LIGHTS - LED BEACON INSTALLATION

The incandescent beacon light (ground recognition) can be replaced with an LED beacon light.

CAB-33-01  
Page 1 of 7

Figure 1. LED Beacon Installation (Sheet 1)

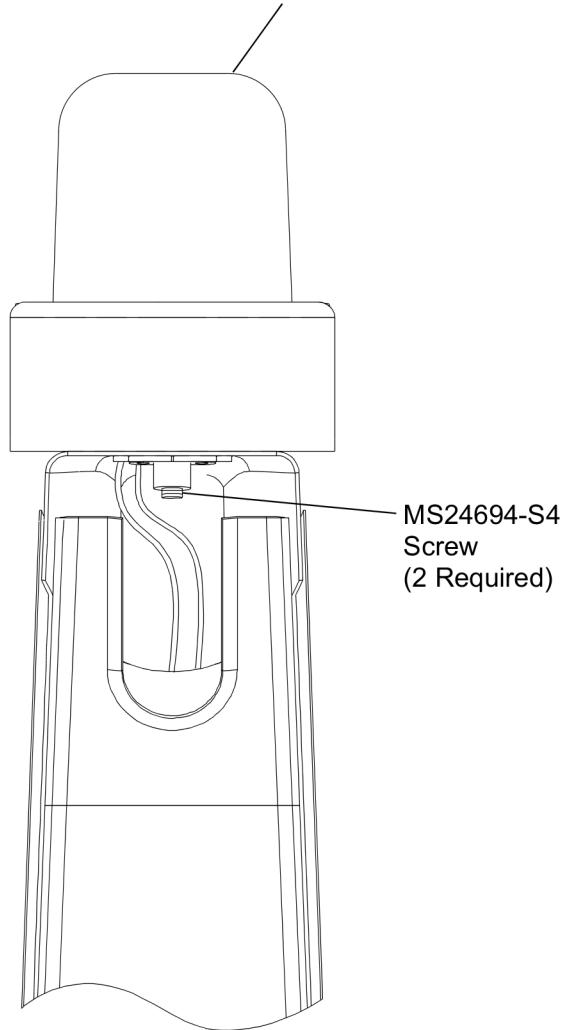
8. Install the 01-0771055-19 LED Beacon Light. (Refer to the Model 208 Maintenance Manual, Chapter 33, LED Ground Recognition Light - Removal/Installation.)

Figure 2. (Sheet 1)

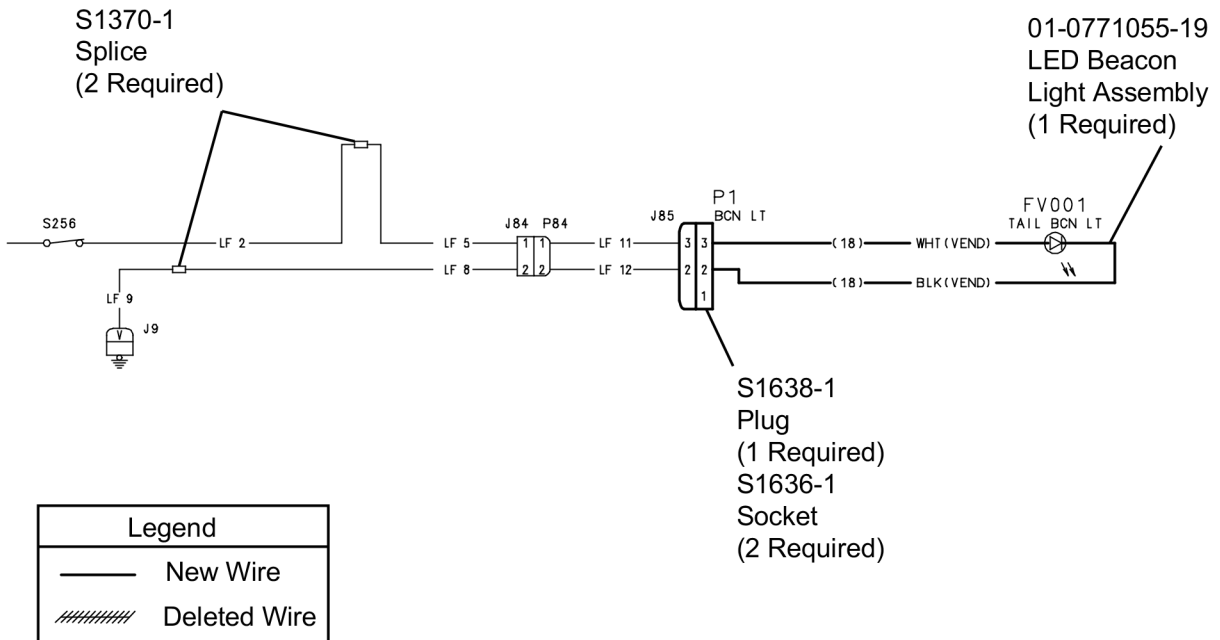
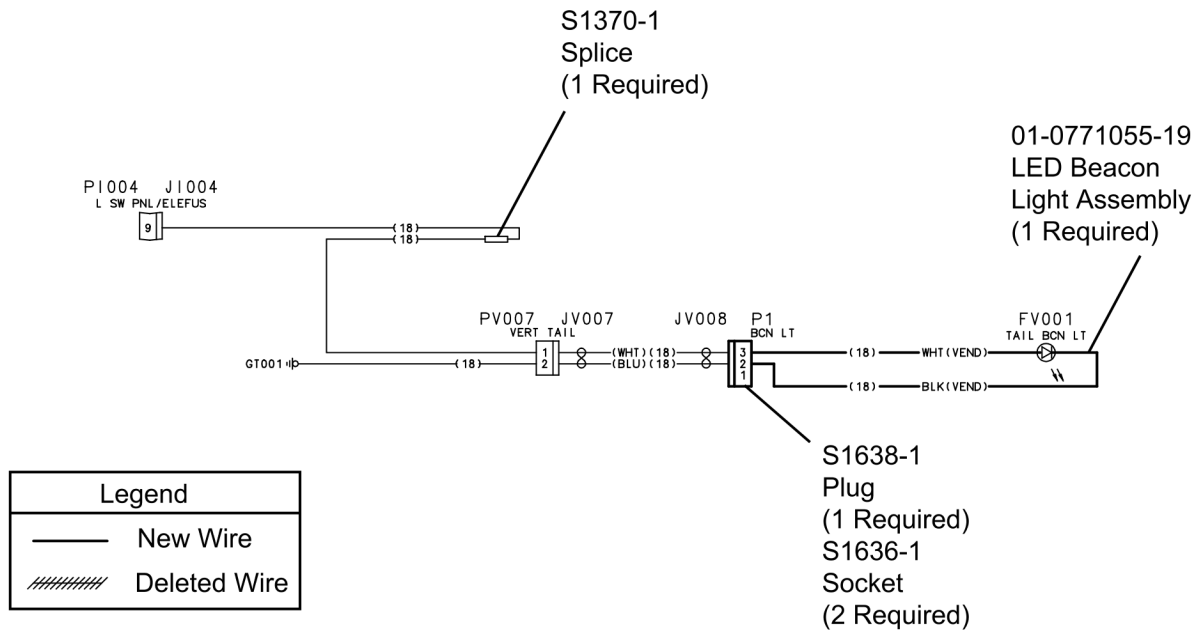
5. (Airplanes 208: -0001 thru -0499 and 208B: -0001 thru -1999.) (Refer to Figure 2, Sheet 1.) Do the wiring modifications as shown.
  - A. Remove the resistor. (Refer to the Model 208 Maintenance Manual, Chapter 33, Incandescent Flashing Beacon - Maintenance Practices, Resistor Removal/Installation.)

- (1) Cut wires 1J106 and 3J106 close to J106 Connector.
    - (2) Cut the wires to remove the splice for wire VJ9-2J84 between J9 and J84 Connectors.

- (3) Remove and discard the deleted wires, resistor, splice and J106 Connector.
  - B. Connect wires aP74 and 1J84 with a S1370-1 Splice.  
**NOTE:** These are the wires that were cut close to J106 in Step 5.A.(1).

- C. Connect wires VJ9 and 2J84 with a S1370-1 Splice.  
**NOTE:** Wire VJ9-2J84 is the wire with the splice removed that had wires BLKFL1 and 2J106.
  - D. Identify two S4111-1A ID Tags with **aP74-1J84** and install each with two S2209-1 Tie Straps.

- E. Identify two S4111-1A ID Tags with **VJ9-2J84** and install each with two S2209-1 Tie Straps.
6. (Airplanes 208: -0500 thru -0663 and 208B: -2000 thru -4999) (Refer to Figure 2, Sheet 2.) Do the wiring modifications as shown.

Figure 2. (Sheet 2)

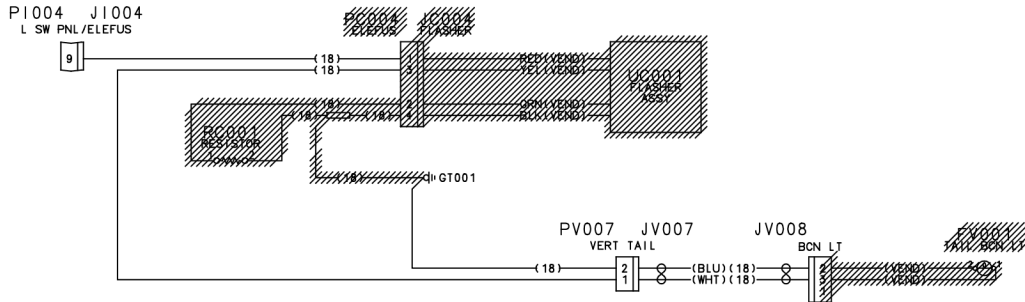
- A. Remove the resistor. (Refer to the Model 208 Maintenance Manual, Chapter 33, Incandescent Flashing Beacon - Maintenance Practices, Resistor Removal/Installation.)

- (1) Cut wires 1PC004 and 3PC004 close to PC004 Connector.
    - (2) Remove and discard the deleted wires, resistor and PC004 Connector.
  - B. Connect wires 9JI004 and 1PV007 with a S1370-1 Splice.

- C. Identify two S4111-1A ID Tags with **9JI004- 1PV007** and install each with two S2209-1 Tie Straps.
7. (Refer to Figure 2, Sheet 1 and Sheet 2.) Do a modification of the 01-0771055-19 LED Beacon Light wires as follows:

- A. Terminate the two wires with two S1636-1 Contact Sockets.
  - B. Install the Black wire to Pin 2 of S1638-1 Plug.
  - C. Install the White wire to Pin 3 of S1638-1 Plug.

- D. Identify one S4111-2A ID Tag with **2P1-BLK FV001, 3P1- WHT FV001** and install with two S2209-1 Tie Straps.
  - E. Identify one S4111-1A ID Tag with **P1** and install next to the P1 Connector with two S2209-1 Tie Straps.
